# Access Compliance Report

## Public Rights-of-Way

### (Curb Ramps)

Intersection ID: 46342	Main Street: BRANDYBUCK_LN	Cross Street: PRAIRIE_VALLEY_DR	Location: SE
ADA ID: B49640E37E77	Ramp Type: PerpDiag	Initial Pass/Fail: Pass	Overall Compliance: No
Severity Score: 21.5			
Codes/Mitigation Info/Possible Solution		Field Measurements/Component Compliance

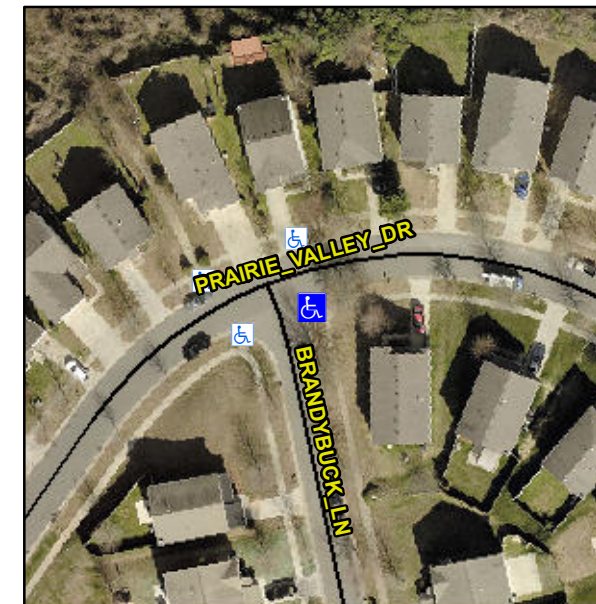
**Not Found, R304.2.1, R304.2.2-Perp, R304.3.2-Para, R305, R302.7.2**

Compliance	Description	Data	Compliance	Description	Data
N/A	Ramp Length (in)	87.0	Yes	Ramp Slope (%)	6.9
Yes	Ramp Width (in)	49.0	Yes	Ramp XSlope (%)	0.4
N/A	Flare Type LT	Sloped	N/A	Flare Type RT	N/A
N/A	Flare Slope LT (%)	5.8	N/A	Flare Slope RT (%)	6.0
N/A	Flare Traversable LT?	No	N/A	Flare Traversable RT?	No
No	Landing Length (in)	45.5	No	DWS Provided?	No
No	Landing Width (in)	45.5	N/A	DWS Contrast?	No
No	Landing Slope (%)	3.0	N/A	DWS Length (in)	N/A
Yes	Landing X Slope (%)	0.9	N/A	DWS Full Width?	No
N/A	Landing Curb? (Y/N)	No	N/A	DWS Offset (in)	N/A
N/A	Shared Landing?	No			
Yes	Gutter Ponding?	No	Yes	Gutter Slope (%)	3.4
No	Gutter Lip Ht (in)	0.5	Yes	Gutter X Slope (%)	0.8
N/A	Painted X Walk1?	No	N/A	Painted X Walk2?	No
	X Walk 1 Direction	To N		X Walk 2 Direction	To W
N/A	X Walk 1 Width (in)	N/A	N/A	X Walk 2 Width (in)	N/A
	X Walk 1 Slope (%)	0.7		X Walk 2 Slope (%)	0.7
	X Walk 1 X Slope (%)	1.6		X Walk 2 X Slope (%)	1.8

N/A	Ramp inside XWalk1?	N/A	N/A	Ramp inside XWalk2?	N/A
	Road Slope (%)	1.1	N/A	Clear Space?	Yes
	Road X Slope (%)	1.1	N/A	Clear Space to XWalk (in)	N/A
Yes	Any Obstructions?	No	Yes	Storm Grate/Utility Hazard?	No
	Obstruction Type			Storm Grate/Utility Type	
		N/A			N/A
			Yes	Surface Condition? (G/P)	Good

**Remove & Replace Curb Ramp With Two New Directional Ramps or Equivalent.**
